**Subject: Response to Portion of NRC Request for Additional Information Letter No. 103 Related to ESBWR Design Certification Application - Control Room Habitability - RAI Number 9.4-33**

**Response to Portion of NRC Request for  
Additional Information Letter No. 103  
Related to ESBWR Design Certification Application**

**Control Room Habitability**

**RAI Number 9.4-33**

Figure 9.4-33-1. CRHA Temperature Profile (Initial Temperature 25.6°C (78°F))

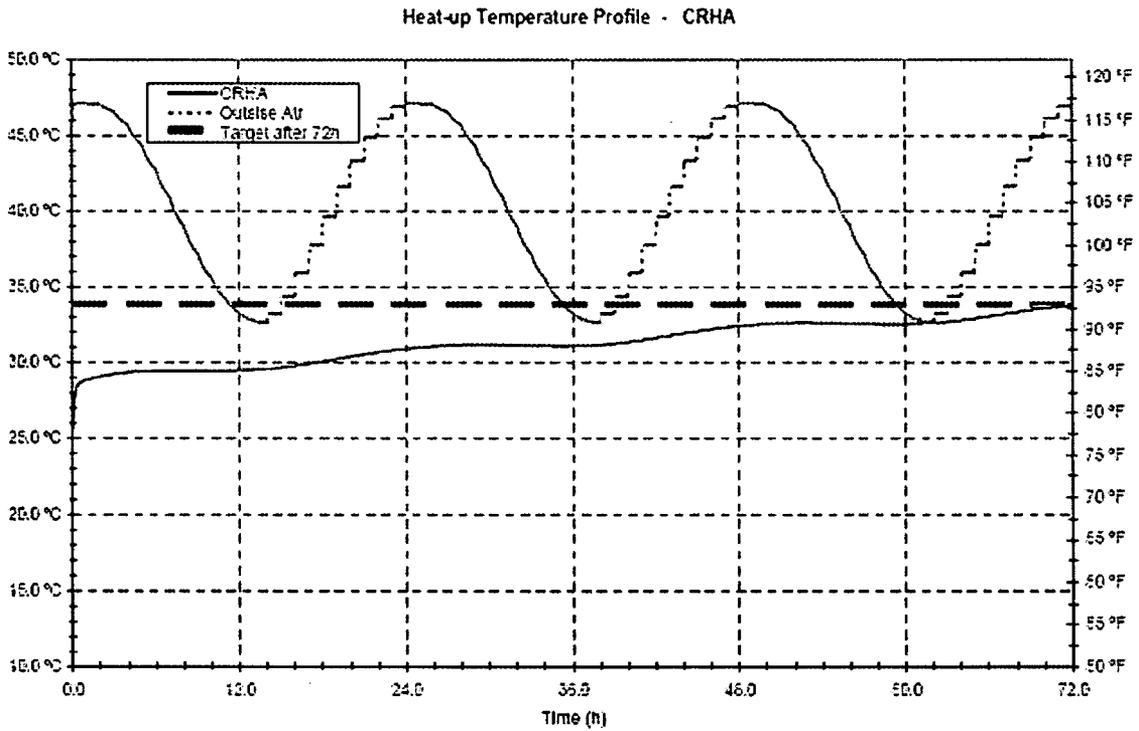
*Provide additional information on how the temperature in the control room changes with time during the 72-hour period following accident initiation. The information should be based on a detailed thermal heat transfer study that considers the temperature of outside air entering the control room, the heat loads in the control room, the rate of heat transfer from the heat producing equipment to control room air, the rate of heat transfer from the control room air to building structures and components that make up the heat sink, the impact of other barriers to heat transfer such as carpets, vinyl layers, false ceilings and floors, and the impact of heat sources on exterior CRHA surfaces, outside air conditioners and other environmental factors on the building heat sink.*

*The staff is concerned that although there is some potential to remove the heat through the heat sink, the rate of heat removal would be much slower than the heat released to the room and the temperatures might exceed limits for personnel and equipment operation.*

A maximum internal heat load of 7375 W is modeled in the CRHA heatup analysis, which includes 375 W of heat added by the EFU fan, which automatically actuates during an extended loss of AC power (DCD Tier 2, Revision 4, page 9.4-3). The remaining heat load of 7000 W is considered conservative based upon expected electrical, electronic and personnel heat loads, with margin. In addition, the analysis models 200 l/s of outside air injection, which accounts for the EFU outside air supply fan. The analysis is performed with an intake temperature profile for a dry bulb temperature of 47.2°C (117°F) and a daily temperature range of 15°C (27°F).

The analysis is based on an initial CRHA temperature of 25.60°C (78.08°F), which represents the upper limit for the normal operational temperature range. The results of the analysis show that the peak CRHA temperature reached after 72 hours was 33.85°C (92.93°F), an increase of 8.25°C (14.85°F). Thus, the main control room temperature increase meets the requirement of DCD Tier 1, Revision 4, Table 2.16.2-4, Item 4a.) to not exceed a 8.3°C (15°F) temperature increase during the first 72 hours after a Station Blackout (SBO) or accident condition. Figure 9.4-33-1 represents the CRHA temperature profile for the respective initial temperature conditions with the DCD Tier 1, Revision 4, Inspections, Tests, Analyses and Acceptance Criteria (ITAAC) for maximum temperature rise above the assumed initial condition.
